Architectural Review and Historic Preservation Board Agenda Report

File : AR 20-13

RE: A 4-plex for French Homes at 192 E. 1st Avenue (APN 003-101-012)

SITE PLAN

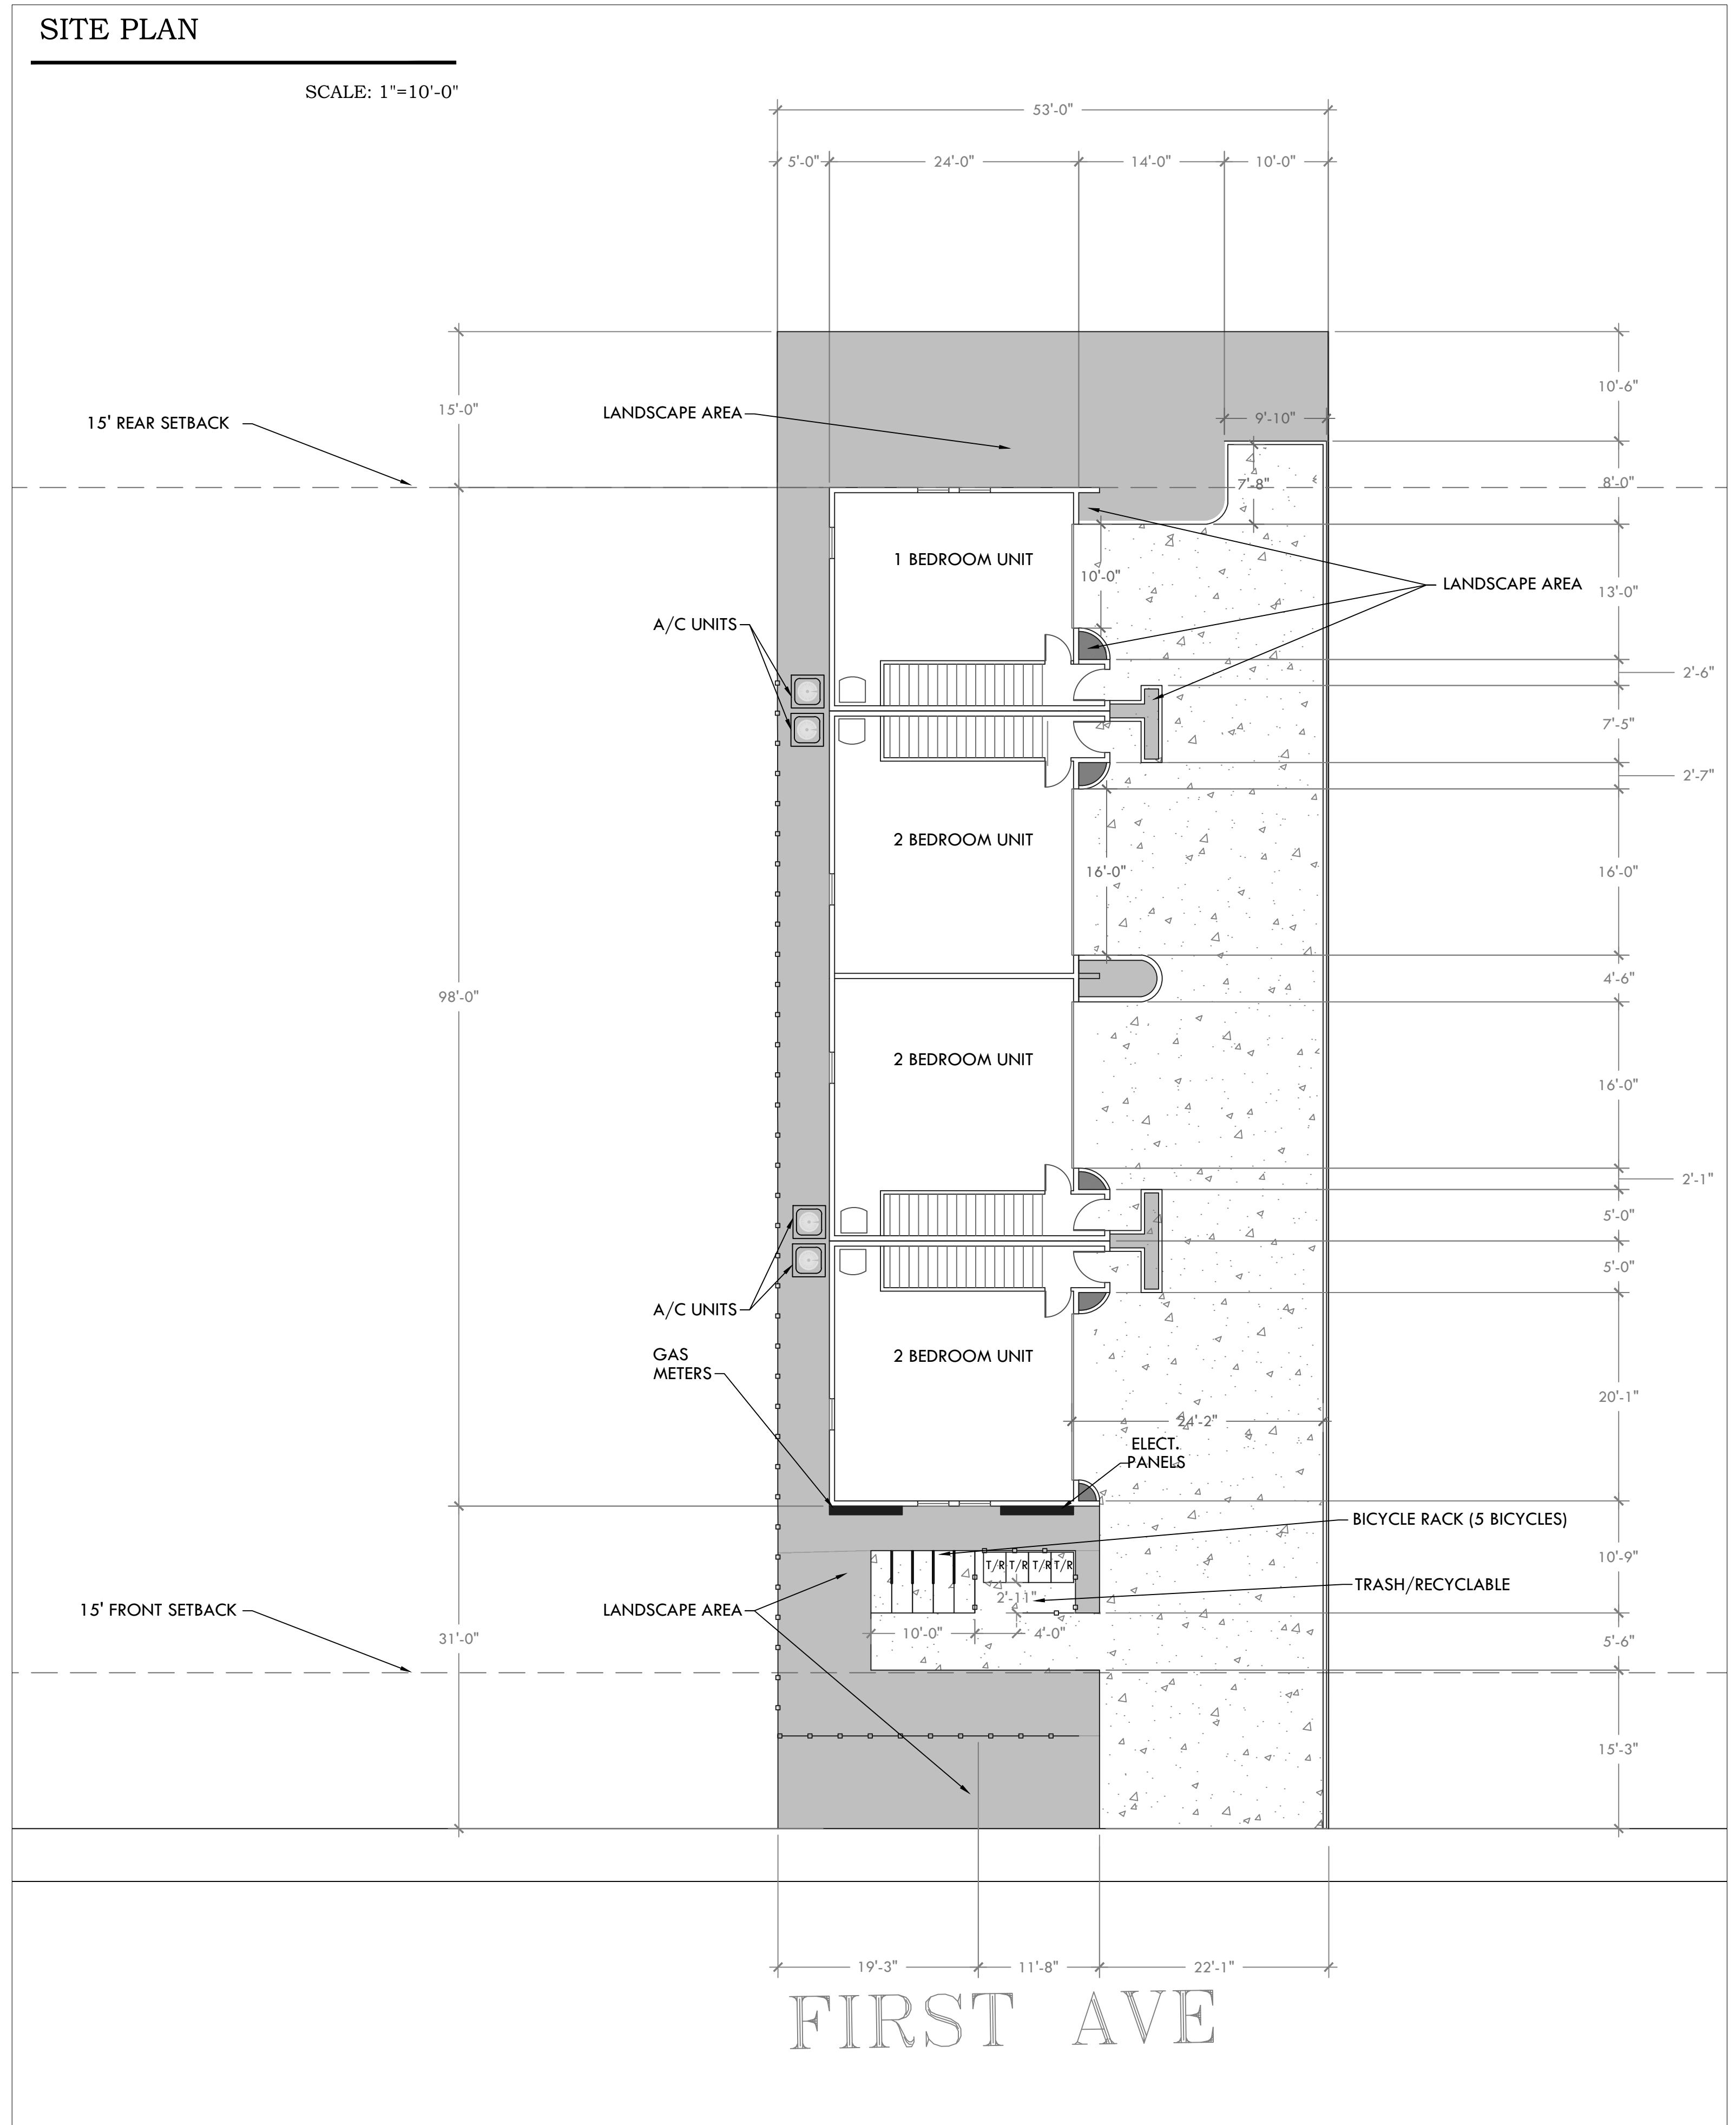
The site plan shows a 6-foot, dog-eared fence across the front yard. To better meet the DGs, staff recommends **Condition #3** to require to a cap and rail atop the fence to reduce monotony along the street side of the project and convey a sense of permanence, better meeting DGs 4.2.31. Additionally, a covered trash enclosure is proposed in the front yard area. Staff recommends adding **Condition #4**, to either change the fencing around the covered trash enclosure to match the cap and rail style fence or upgrade the trash enclosure to a design that better matches the building architecture.

Parking lot shading would meet the code requirement, with 58% of the parking area projected to be shaded in 15 years. The R3 district requires 35% of the area to be landscaped however this site plan shows on 29% of the project site being landscaped. Staff therefore recommends **Condition #6** to ensure the project meets this requirement.

7. AC condenser units shall be moved such that they do not encroach within the required 3ft side yard setback from accessory structures.

3. Upgrade the 6 ft dog-eared fence along the front yard to a cap and rail style to reduce monotony along the street side façade
4. Change the fencing around covered trash enclosure to match the cap and rail style fence or upgrade the trash enclosure to a design that better matches the building architecture.

6. Subject to Planning staff approval prior to issuance of a building permit, a revised, detailed, final landscape plan shall be submitted. The landscape plan shall meet the 35% landscaping requirement for R3 zoning district. Additional landscaping can be provided in the open space area in rear of the lot, by increasing the landscaped planter area in front of each unit or by adding permeable pavers to the driveway area.

LANDSCAPE PLAN

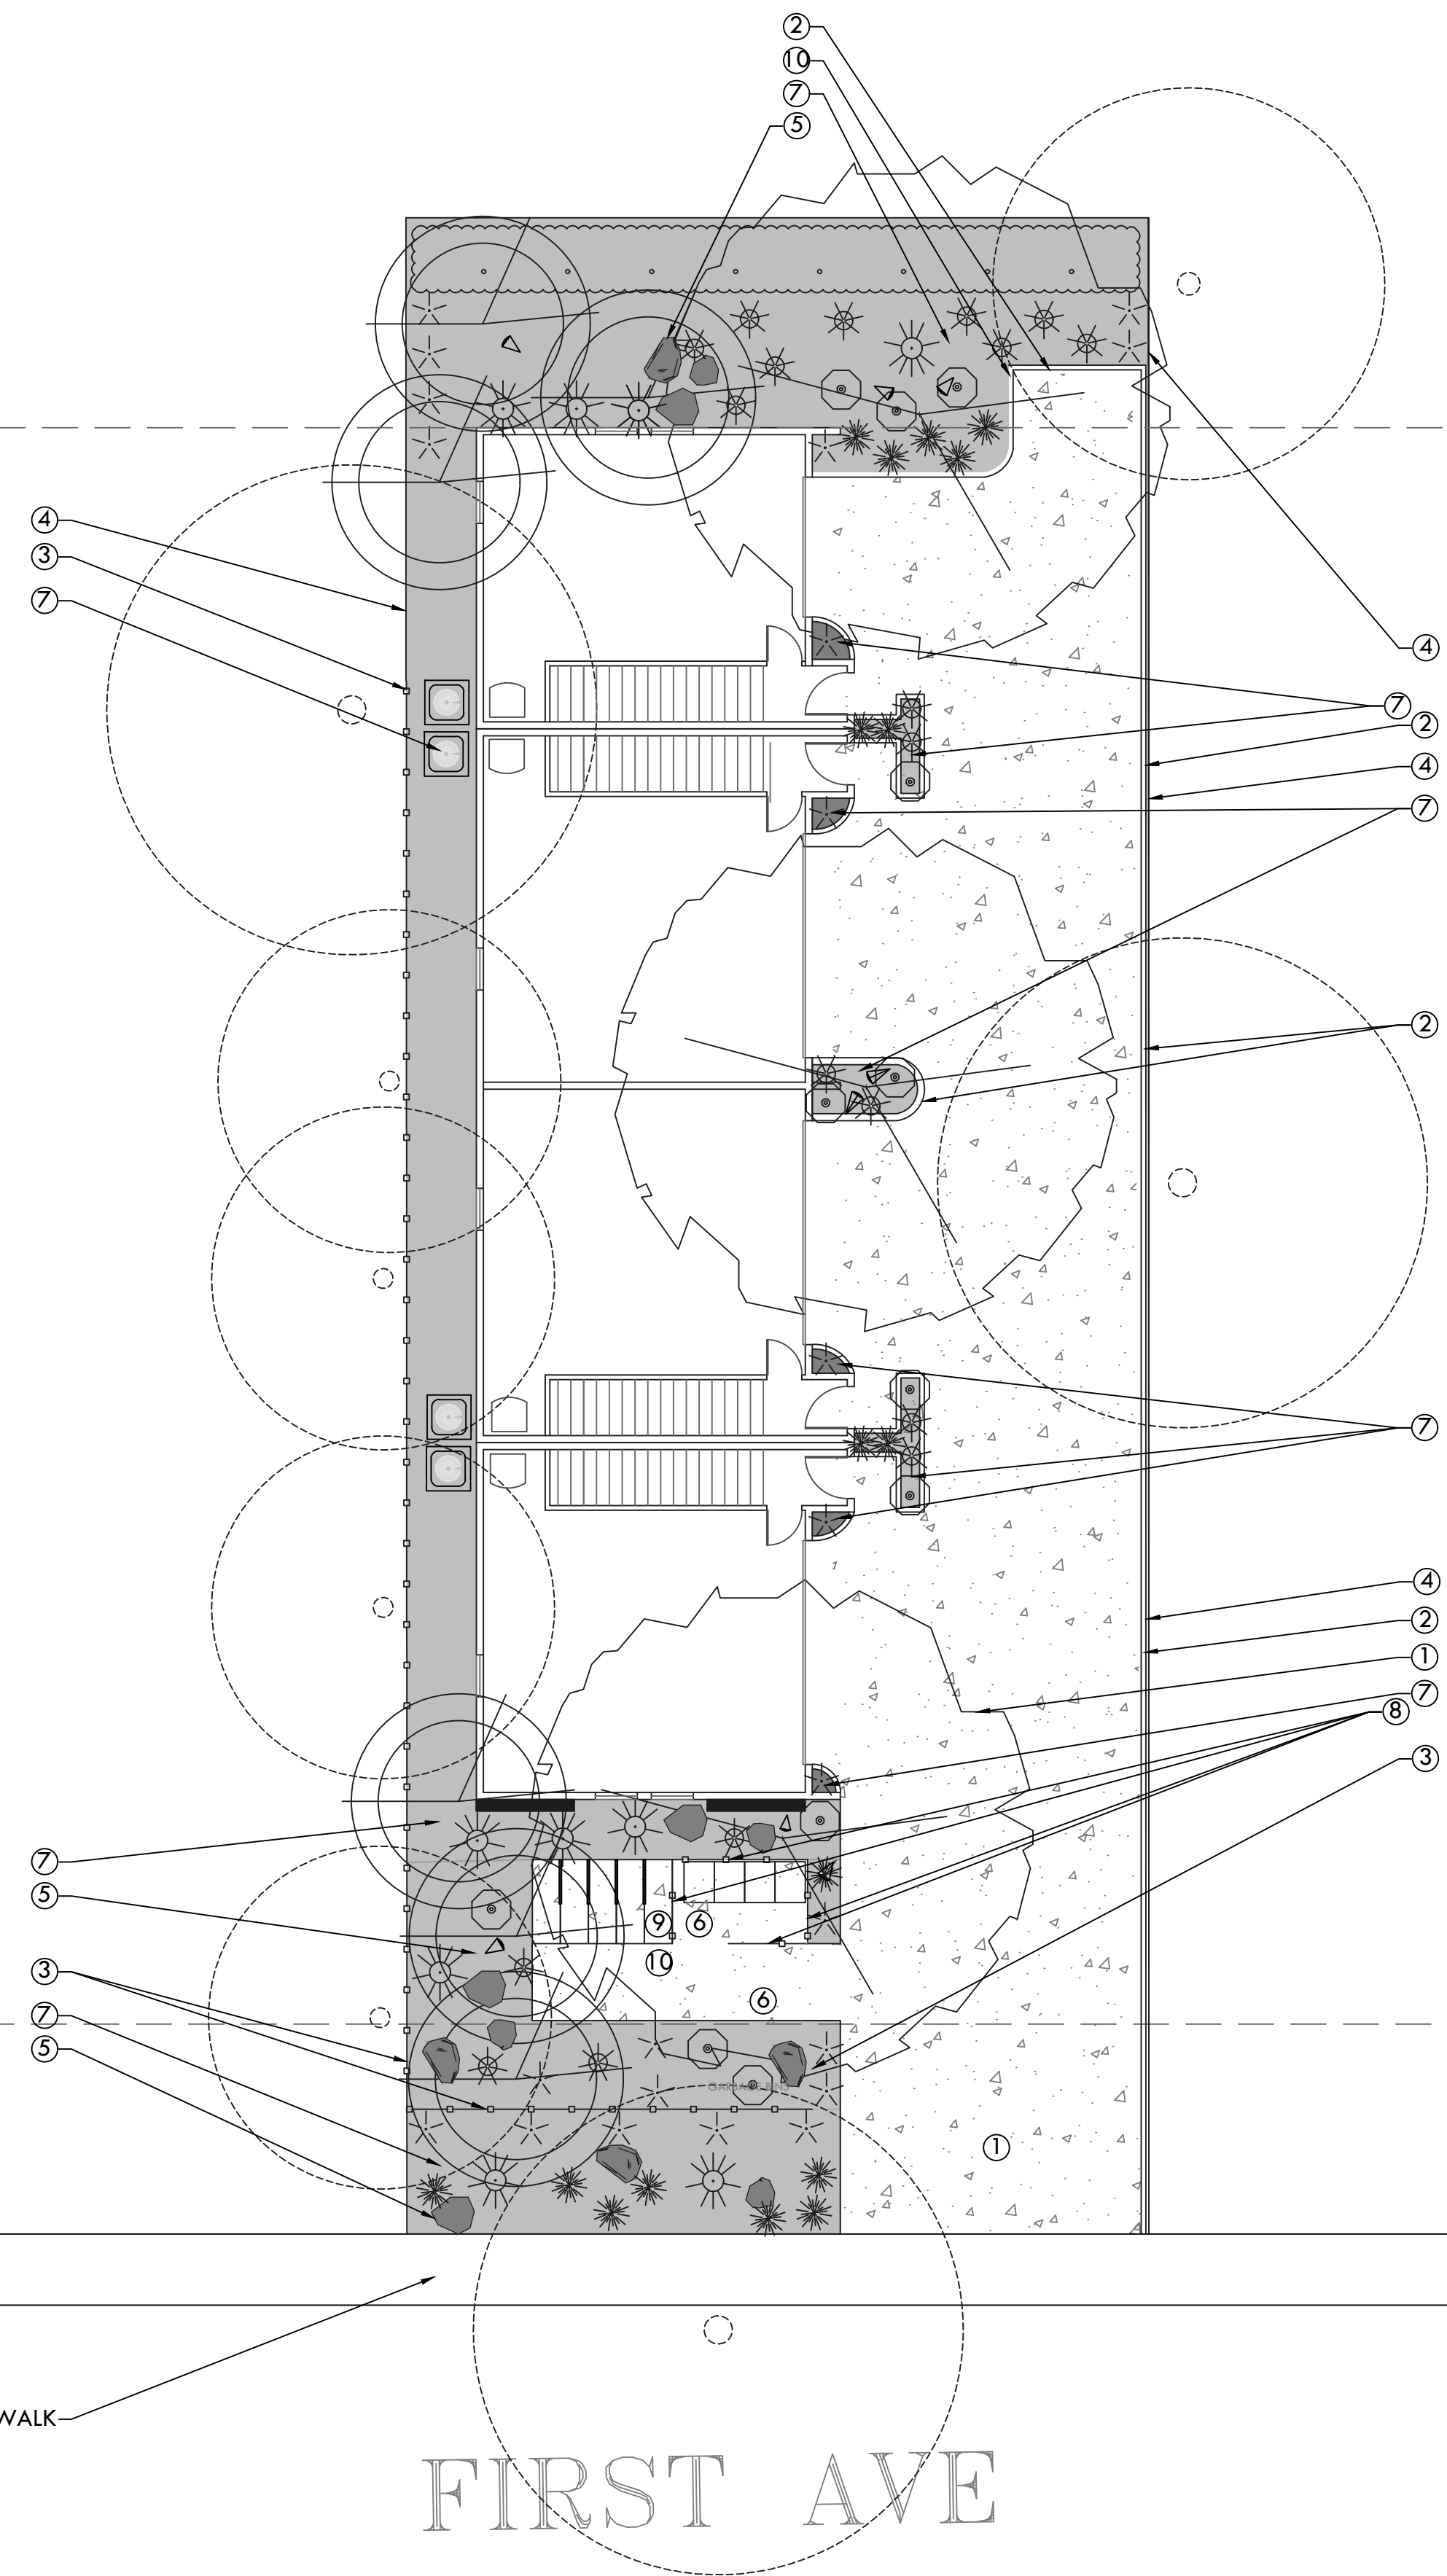
There is very little room to provide usable open space at the site, however an opportunity appears to exist for a common patio area in the back of the lot. To achieve better consistency with the DGs, specifically DG 4.1.42 and DG 4.1.43, **Condition #5** is recommended to require constructing a new surface of paver stones, bricks, or similar with patio cover/ trellis at that location to create a usable, shared outdoor recreation area.

5. A usable outdoor area with all-weather surface shall be constructed in the rear of the lot by constructing a new surface of paver stones, bricks, or similar with a patio cover/trellis.
